Addendum No. 001

Quotation: Parking Lot Upgrades at the Eastview Landfill

Item No: #L-38/26 City File #88/26

Date: July 3, 2026

OVERHEAD PICTURE

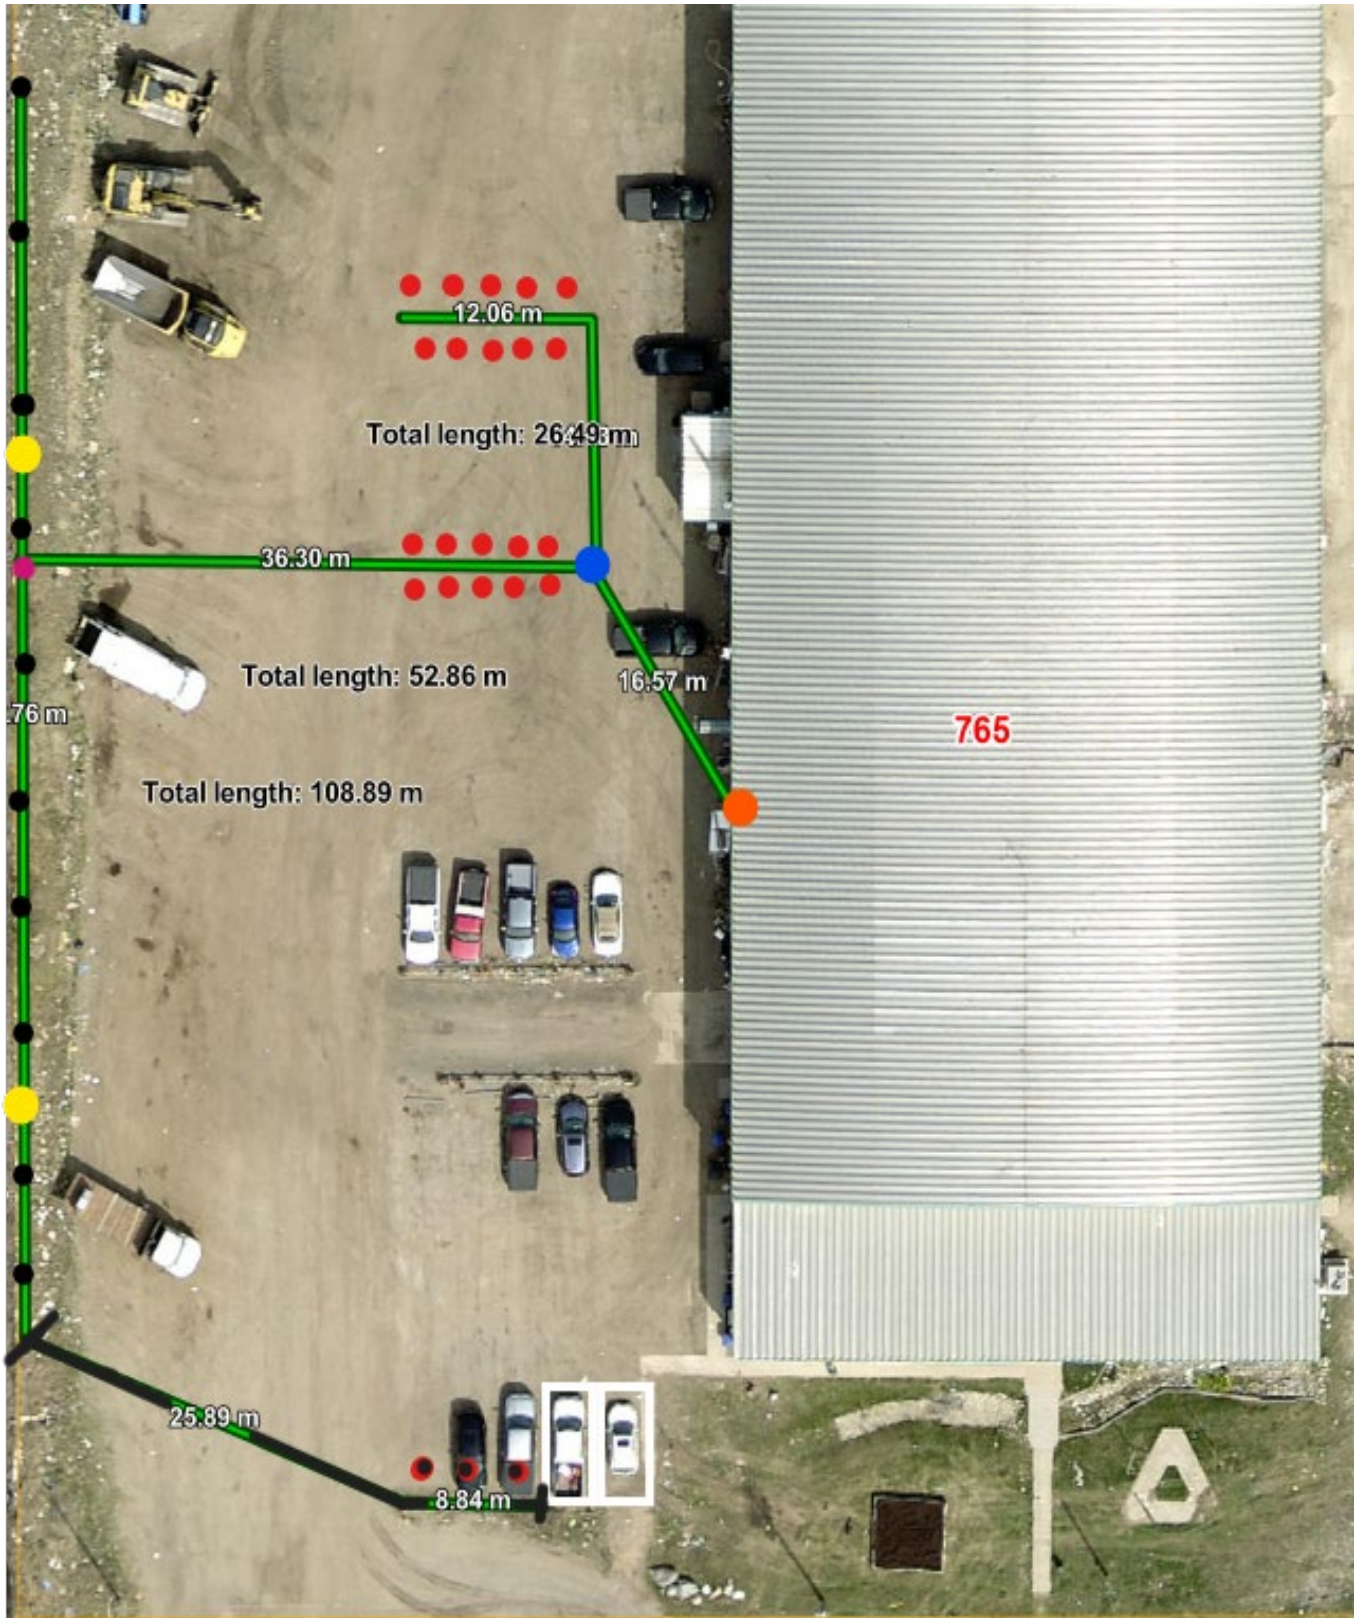
- A.1.1 Approximately **137 meters (450 feet)** of trenching is required. Bidders are responsible to take their own measurements. Refer to Appendix 2-v2 for location of trench work (shown as green lines).
- A.1.2 The parking lot will remain gravel once trenching is completed.

- A.3.1 Supply and install electrical receptacles on wood rails
 - A.3.1.1 **20 stalls** for domestic vehicle use. Refer to Appendix 2-v2 for locations (shown as red dots).

- A.3.1.2 The two (2) parking spaces along the southern row of parking do not require electrical. Refer to Appendix 2-v2 for location (outlined in white).

- A.3.2 Supply and install two (2) 300-watt yard lights along west parking rail. Refer to Appendix 2-v2 for locations (shown as yellow dots).
- A.3.3 Supply and install one (1) **50kva** transformer in a centralized location to minimize wire size. Refer to Appendix 2-v2 for locations (shown as blue dot).

- A.3.4 **Supply and install one (1) 100 amp subpanel. Refer to Appendix 2-v2 for location (shown as a pink dot).**
- A.3.5 Tie electrical into 600-volt **MCC with existing 50 amp 3-pole breaker** panel located inside the Material Recovery Facility on the west wall. Refer to Appendix 2-v2 for locations (shown as orange dot).

- A.4.1 Approximately **35 meters (114 feet)** of trenching is required. Bidders are responsible to take their own measurements. Refer to Appendix 2-v2 for location (shown as black lines).
- A.4.2 The parking lot will remain gravel once trenching is completed.

- A.6.1 Supply and install electrical receptacles on wood rails.
 - A.6.1.1 **20 stalls** along the west fenceline parking rail. Refer to Appendix 2-v2 (shown as black dots)
 - A.6.1.2 **3 stalls** on the southern row. Refer to Appendix 2-v2 (shown as red dots with black dots inside).

1. Refer to Appendix 2 – Overhead Picture – Replace with Appendix 2-v2 Overhead Picture, which is amended to this Addendum.
